Re: 290 UNLEY ROAD, HYDE PARK – RESPONSE TO SUBMISSIONS FOR APPLICATION ID24037925

As requested, SALT provides the following response to the representations which have been submitted in response to the public notification of the above application, including the MFY letter dated 17 January 2025. The MFY letter confirms that application drawings prepared by SMFA dated 7 November 2024 and traffic and waste reports prepared by SALT have been reviewed. Ms Melissa Mellen states that she has visited the subject site.

Figure 1 ROW & 290 Unley Road crossover on Esmond Street peak hour vehicle movements

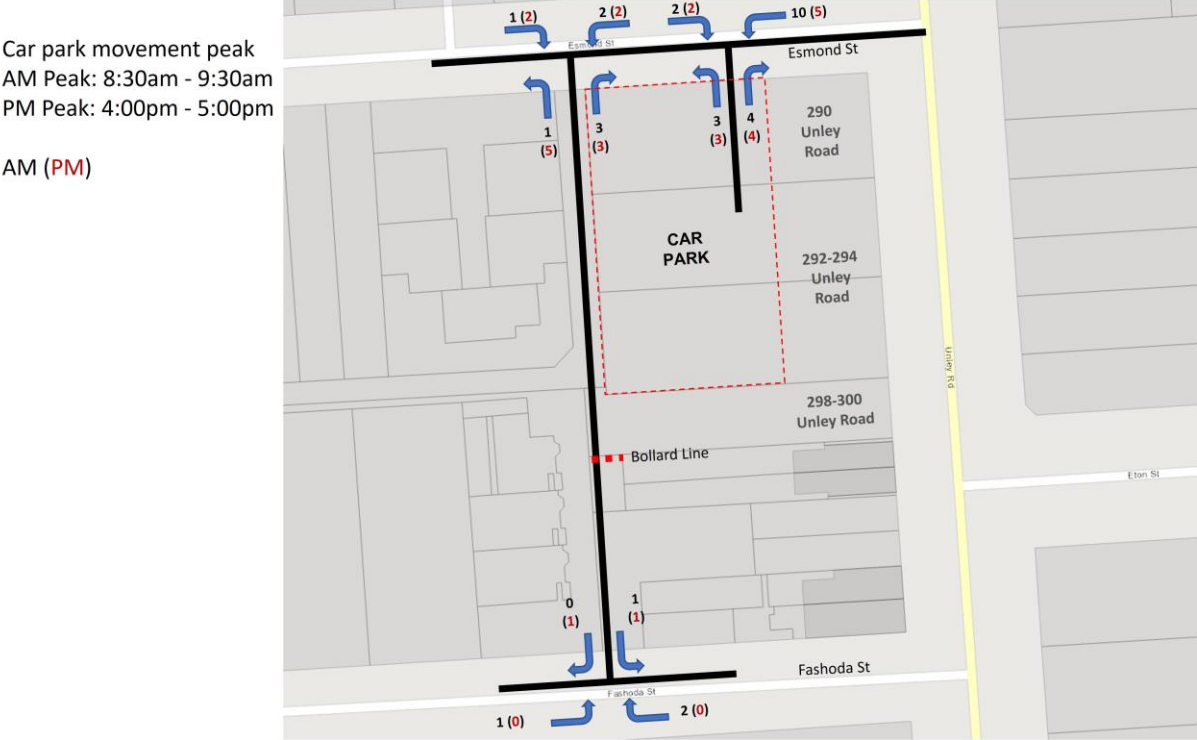
To further appreciate current access that is occurring on the ROW and through the 290 Unley Road private land, SALT collected traffic movement data on Wednesday 5th February 2025 between 4pm and 6pm and on Thursday 6th February between 7.30am and 9.30am. This peak hour movement data is shown below, noting that the AM peak hour occurred from 8.30-9.30am and the PM peak hour occurred between 4-5pm.

The survey shows that during the AM peak hour, there were 7 movements in and out of the ROW via Esmond Street and 19 movements in and out from the 290 Unley Road crossover on Esmond Street, totalling 26 movements in and out. These 26 movements include those generated by 290 Unley Road and the adjacent tenancies, north of the bollards.

The survey shows that during the PM peak hour, there were 12 movements in and out of the ROW via Esmond Street and 14 movements in and out of the crossover at 290 Unley Road, also totalling 26 movements in and out generated by 290 Unley Road and the adjacent tenancies, north of the bollards.

Figure 2 – Vehicle Access to Parallel Space

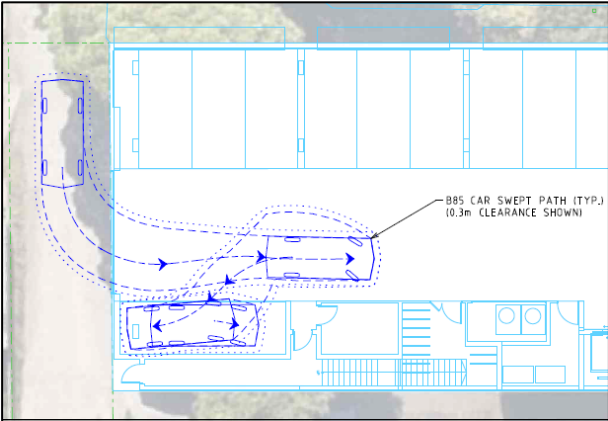
MFY: access to Space 15 requires that drivers park facing the incorrect direction, in breach of the Australian Road Rules.

SALT has already demonstrated that vehicles can access space 15 in a forwards direction by turning around within the carpark. Regardless, vehicles prop on the opposite side of carparking aisles to manoeuvre into/out of parking spaces across private land commonly in Australia. It is a carparking accessway for manoeuvring, not a road, so the ARR would not be applied in the same manner. A vehicle will be able to access the parking space and a column will be relocated to further facilitate this (Figure 2). The vehicle would reverse into the space then move forward to position fully within the space. The vehicle could then turn within the parking

aisle, utilising the space (Figure 3) to then exit the site in a forward direction, or exit the space and turn around at the end of the car park (Figure 4) and then leave the site in a forward direction. The vehicle could also park in the direction of travel to the exit by first turning around at the end of the car park (Figure 4).
